# LATIGO TRAILS FILING NO. 10

# ROADWAY CONSTRUCTION PLANS

ROADWAY CONSTRUCTION PLANS FOR:  
**LATIGO TRAILS  
FILING NO. 10**  
EL PASO COUNTY  
FALCON, COLORADO

COVER SHEET

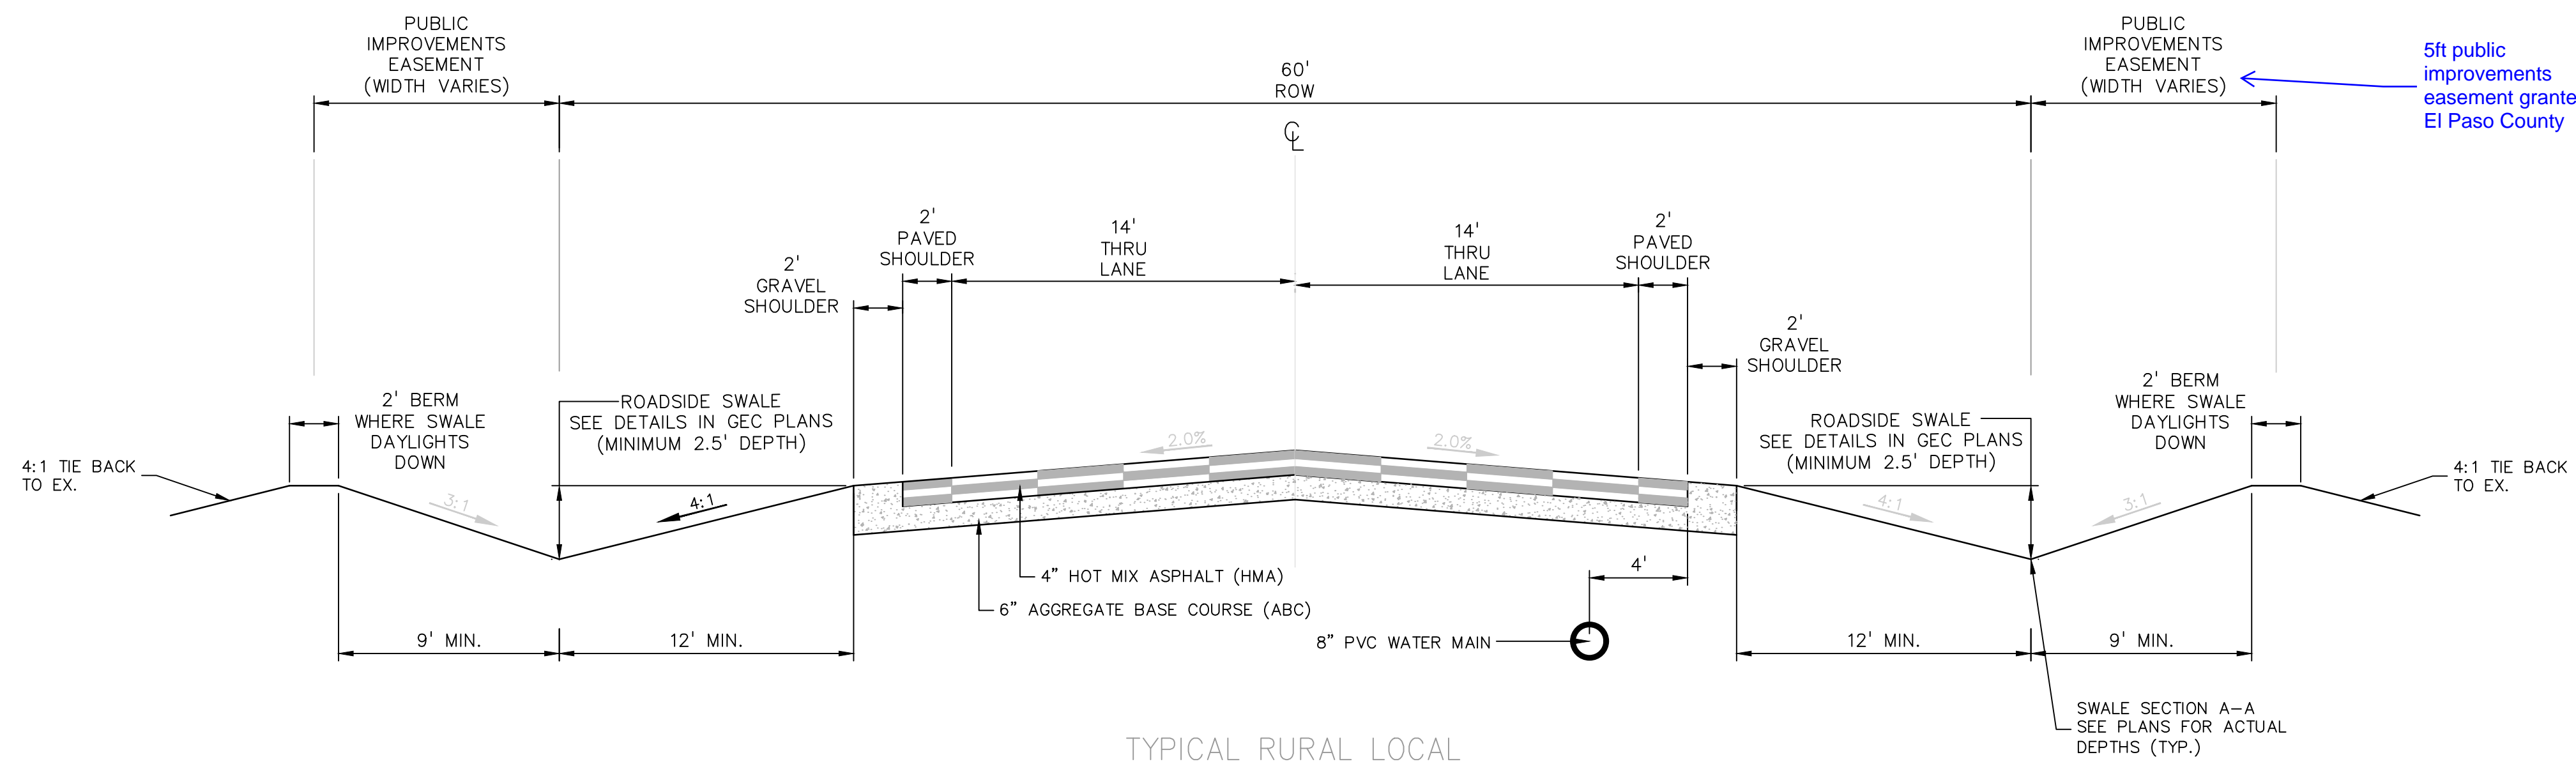
Please provide the construction drawings for the Eastonville Rd upgrades included in this project.

**TYPICAL SECTIONS**  
 PROJECT NO. 21820-01CSCV  
 DRAWING NO.

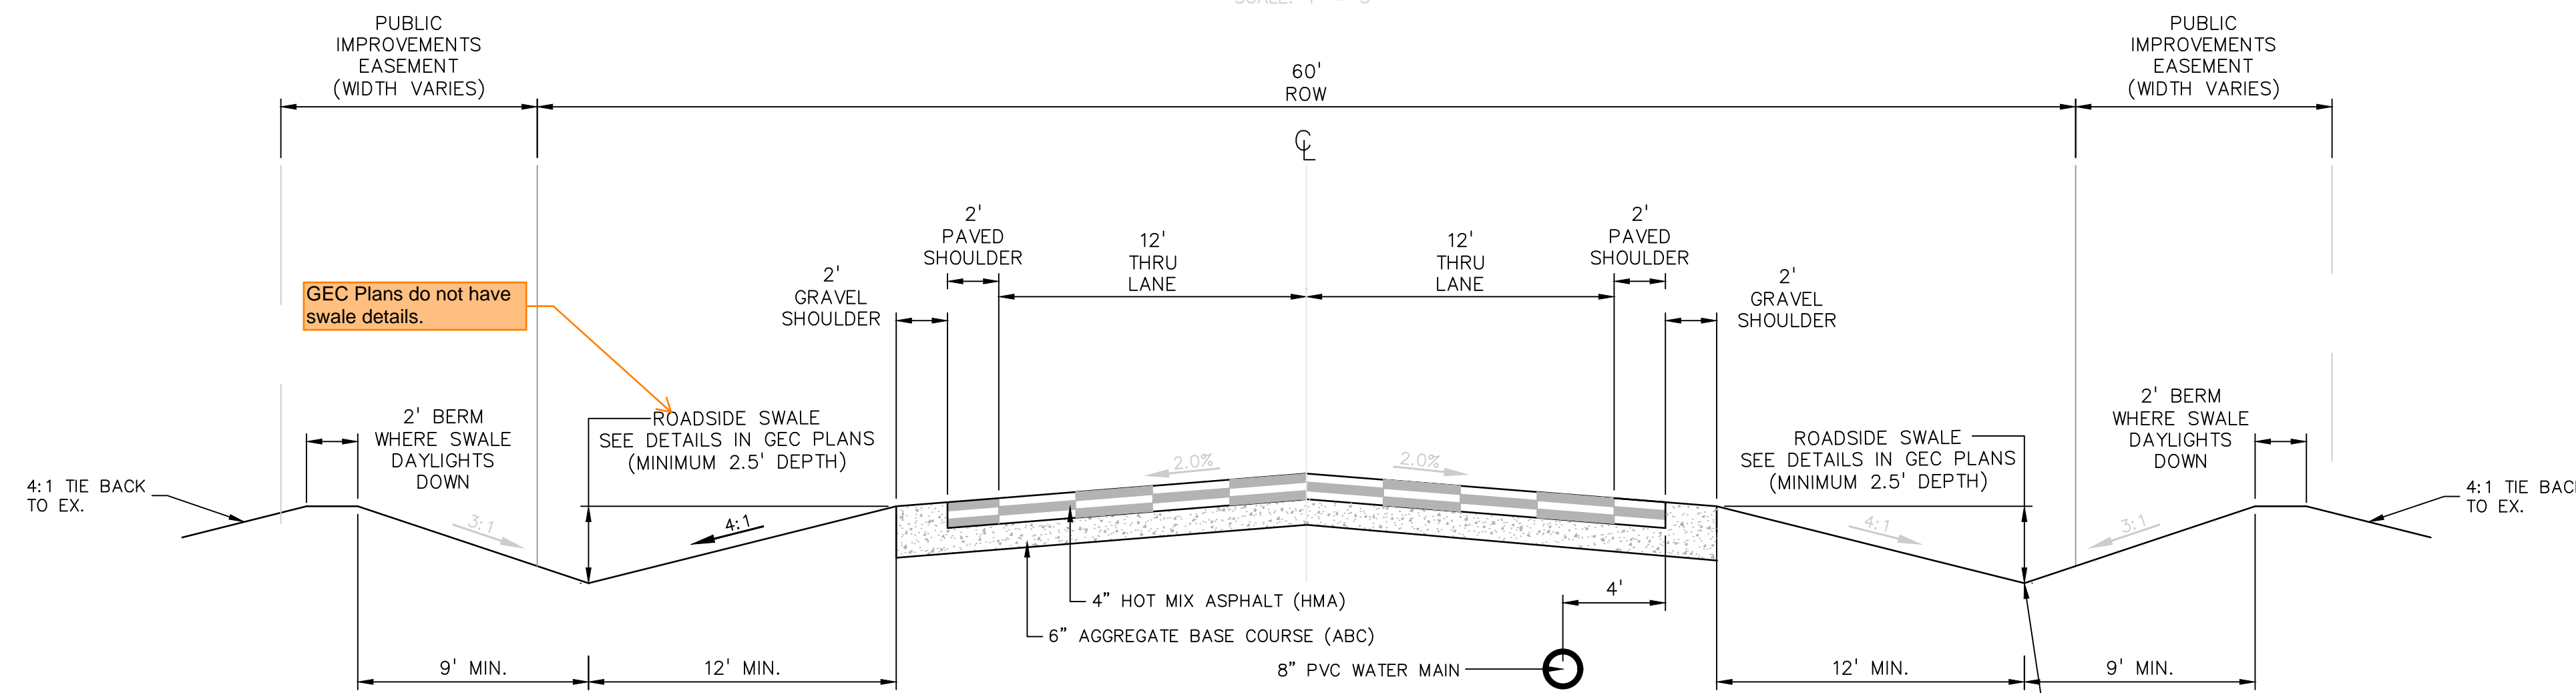
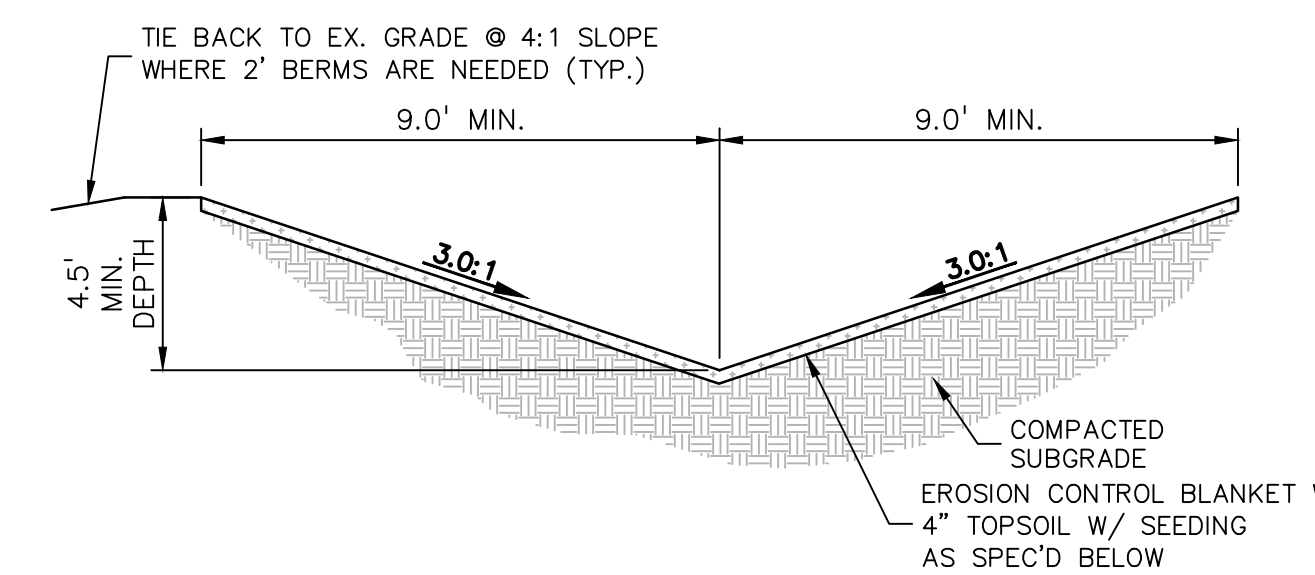
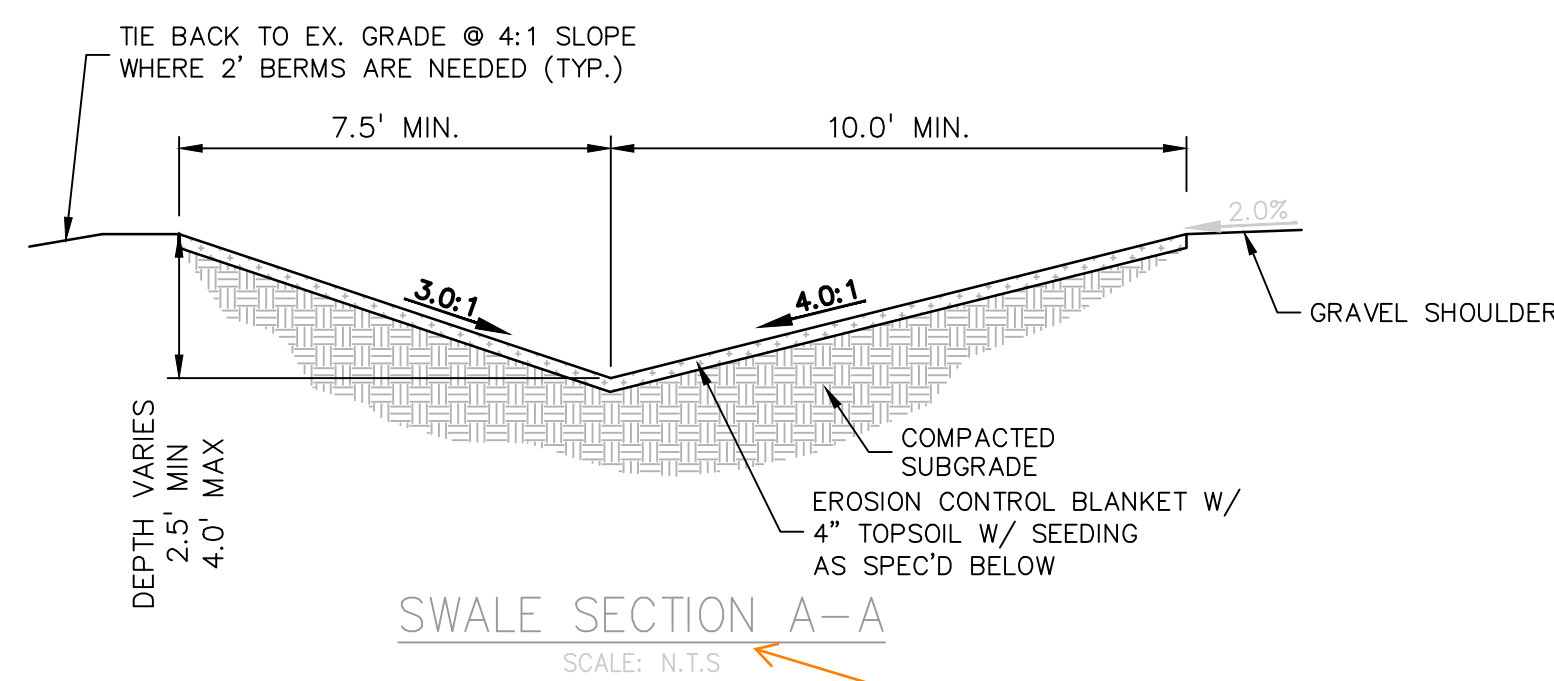
Where do these cross-sections apply?

## HORIZONTAL CONTROL PLAN

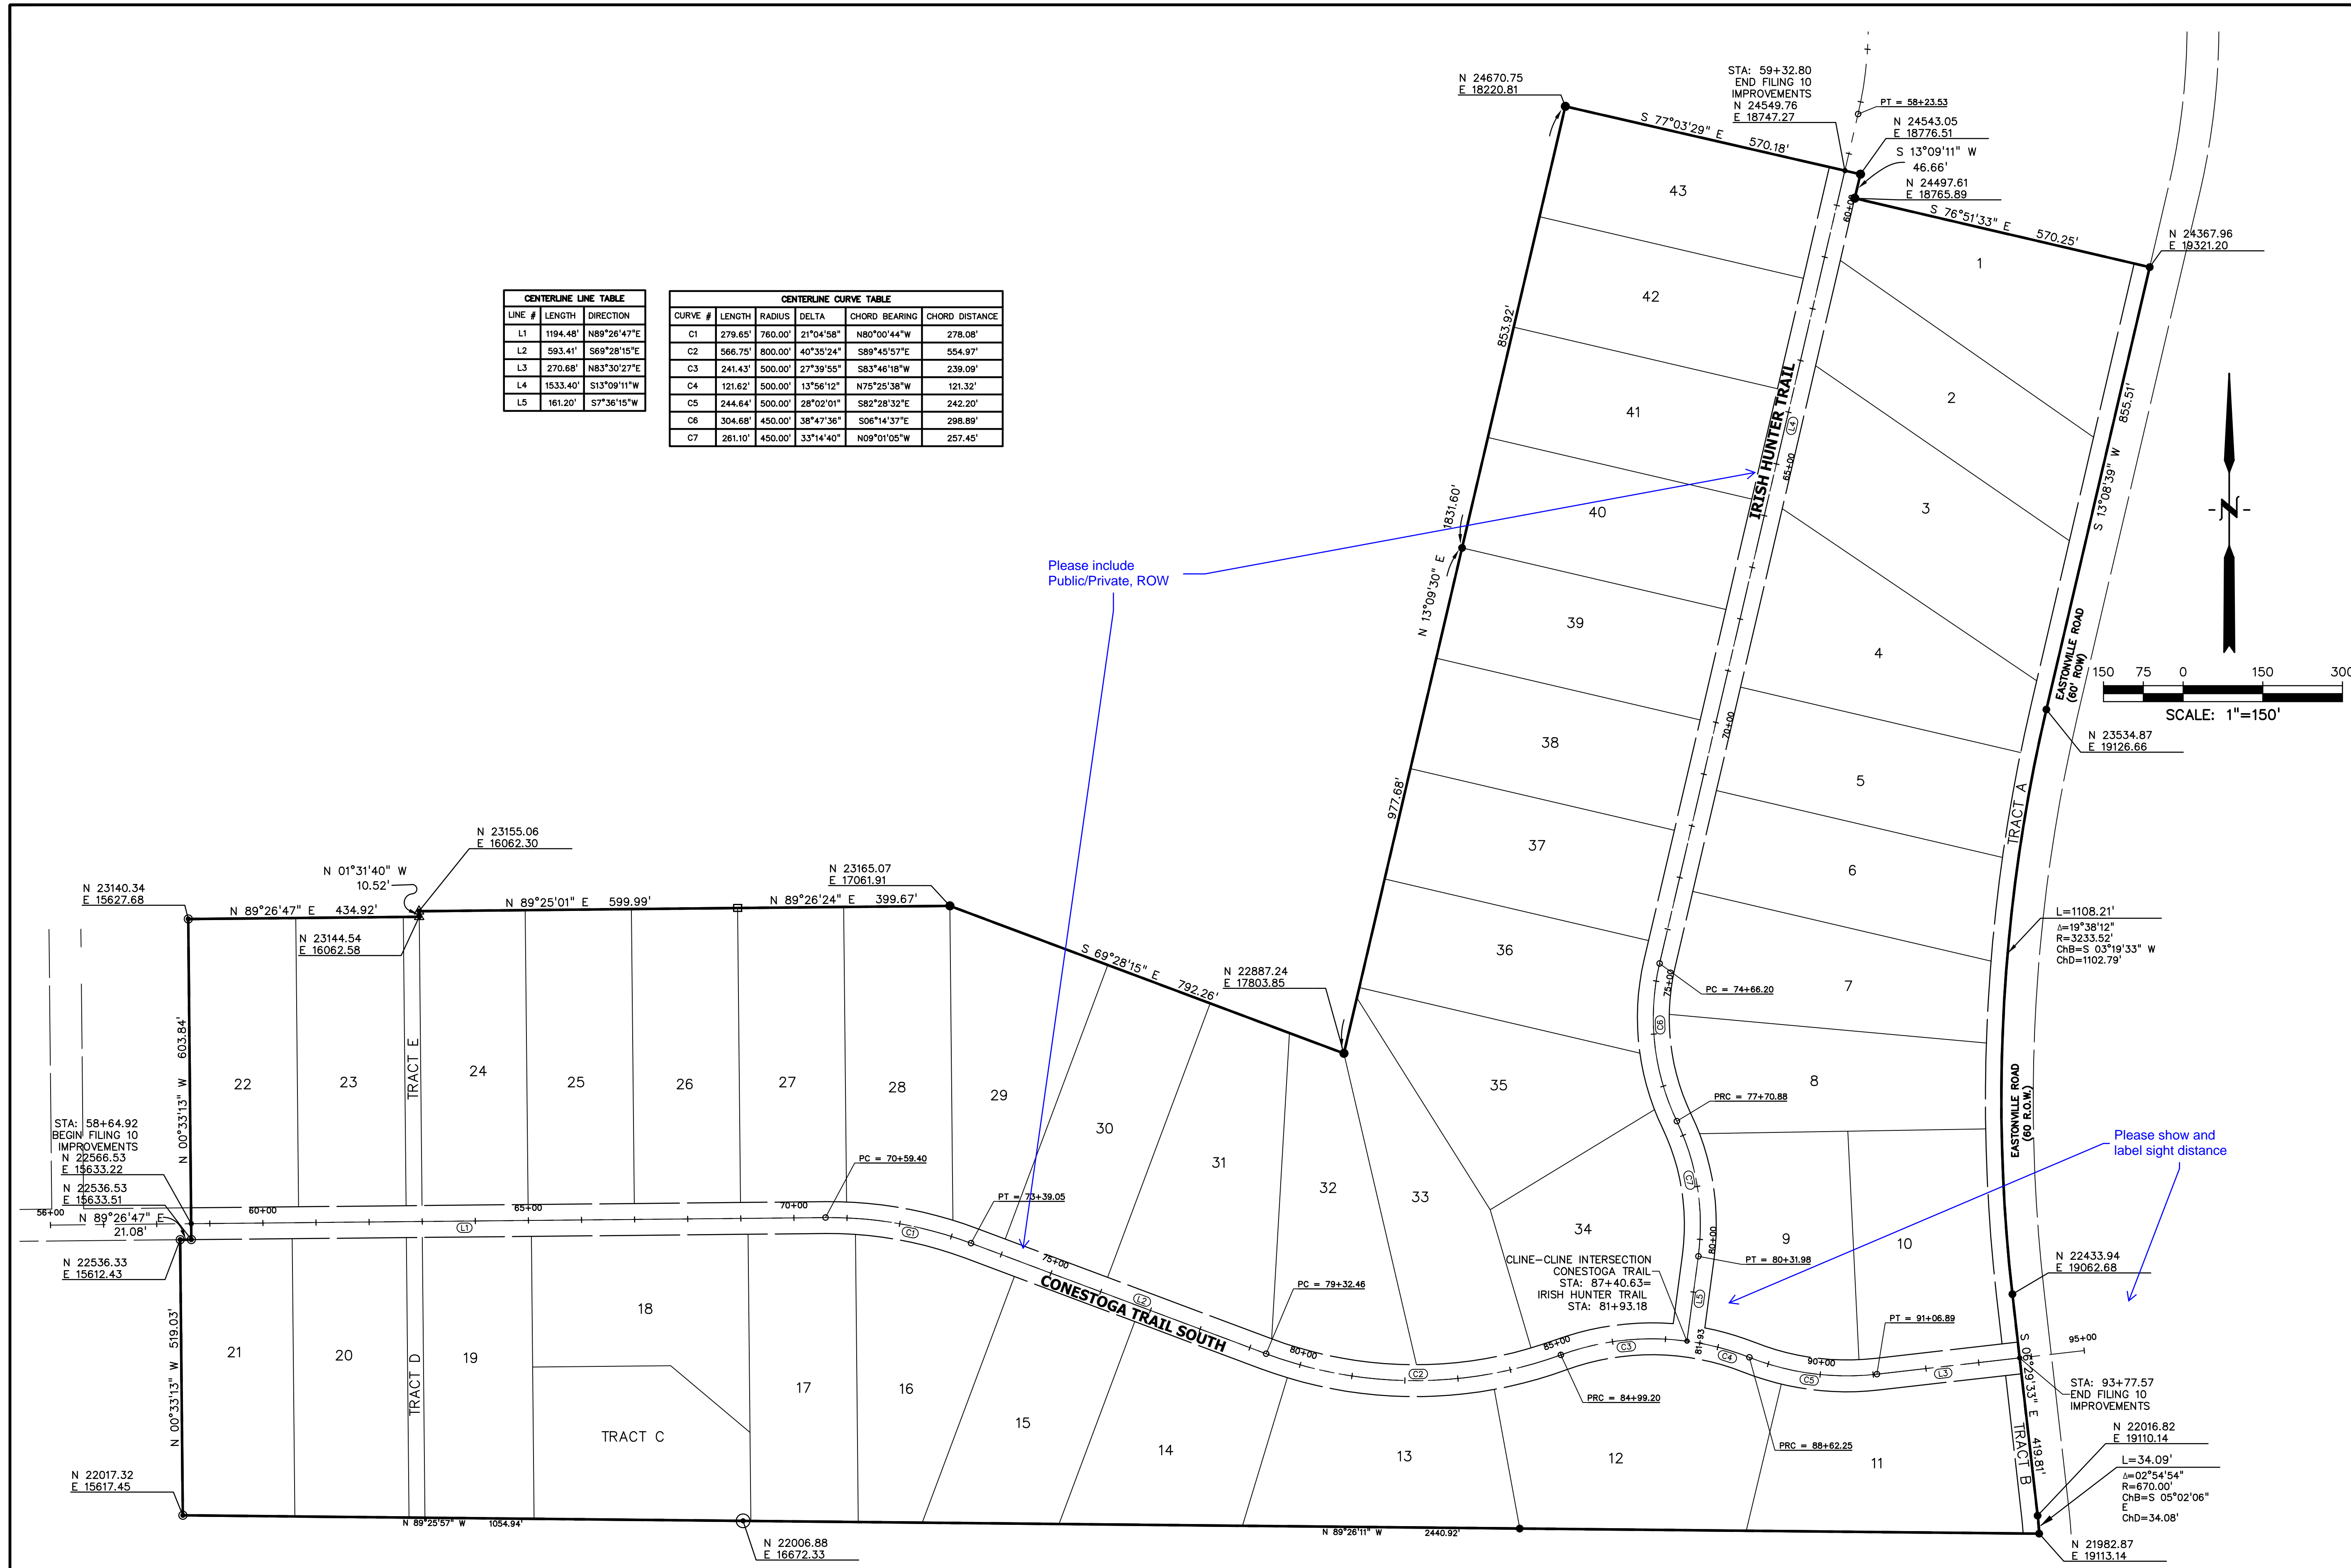
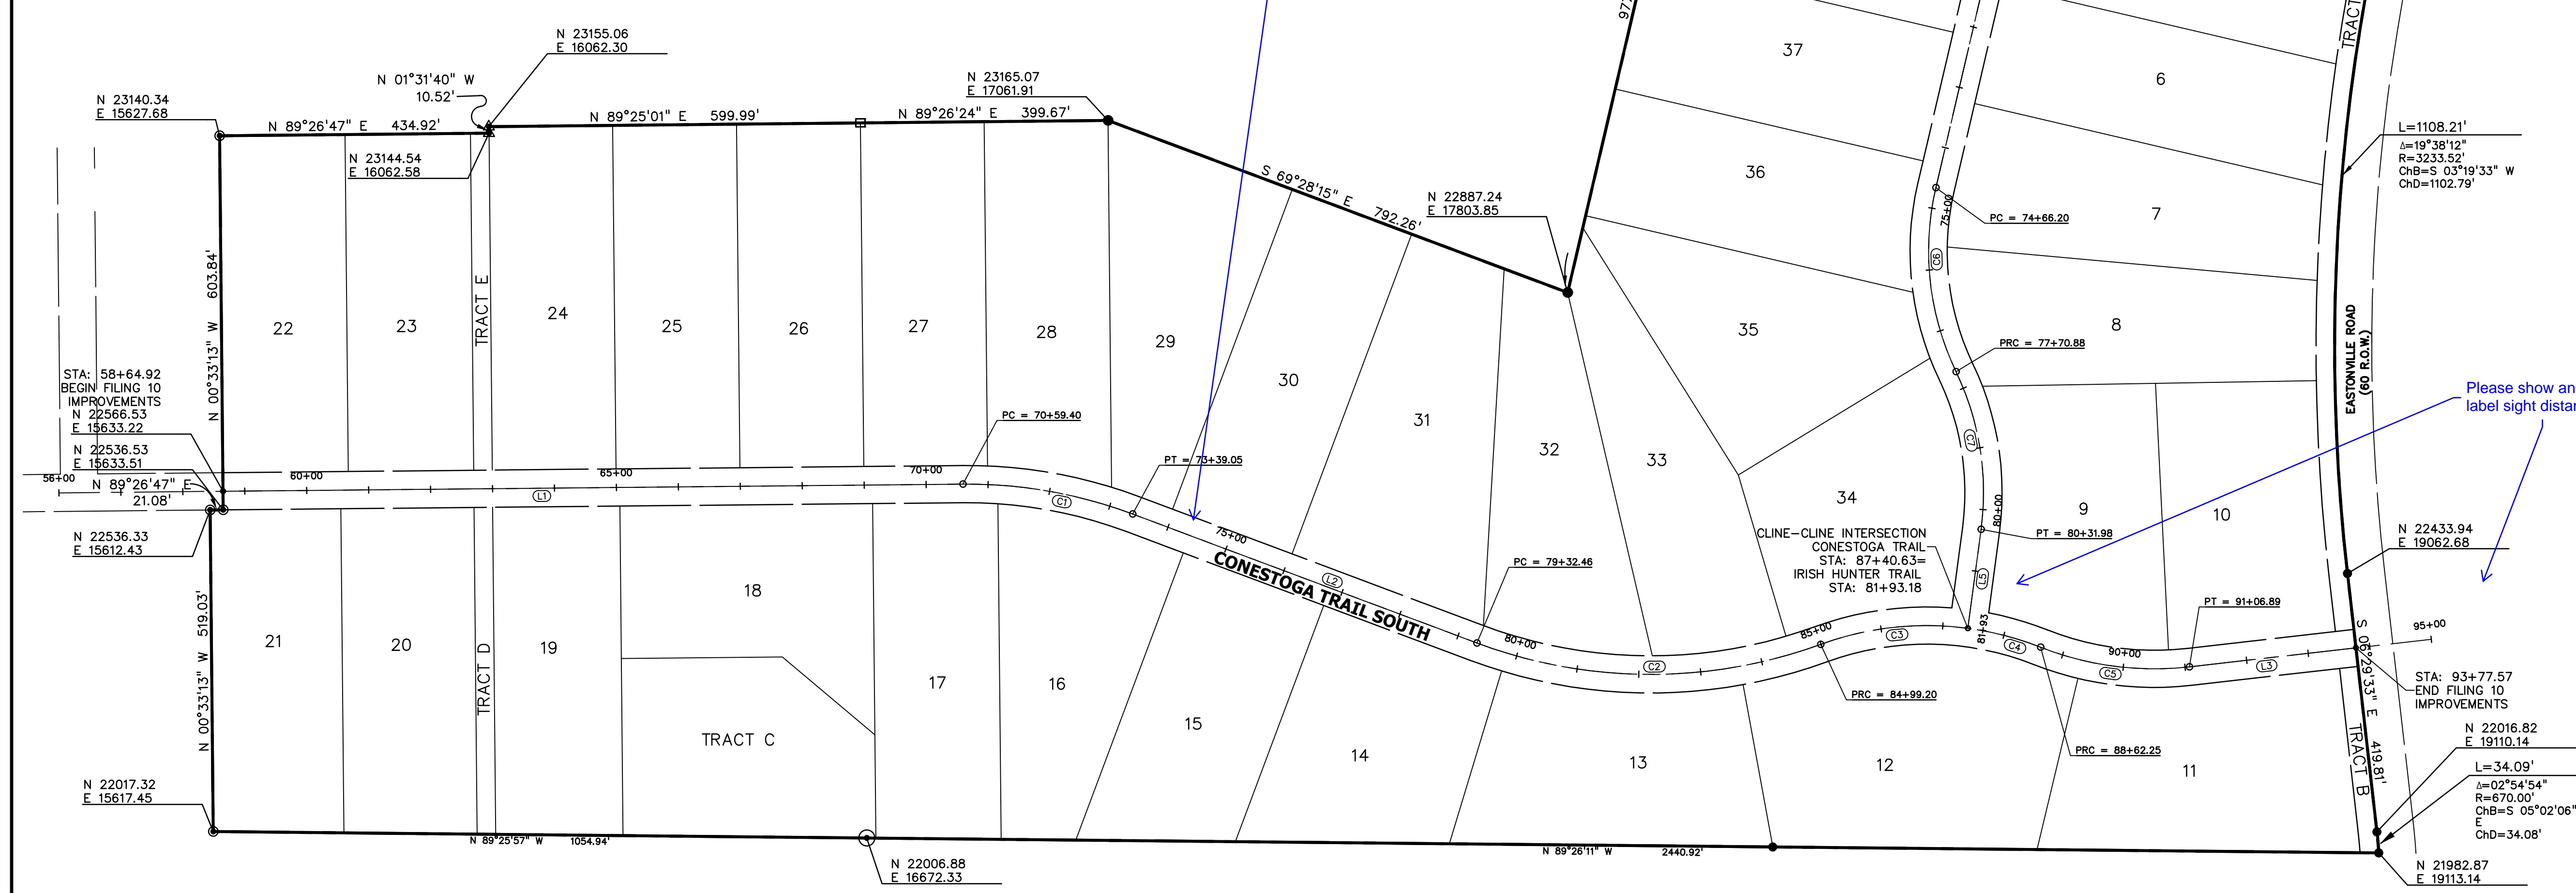
Please include  
Public/Private, ROW

Please show and  
label sight distance
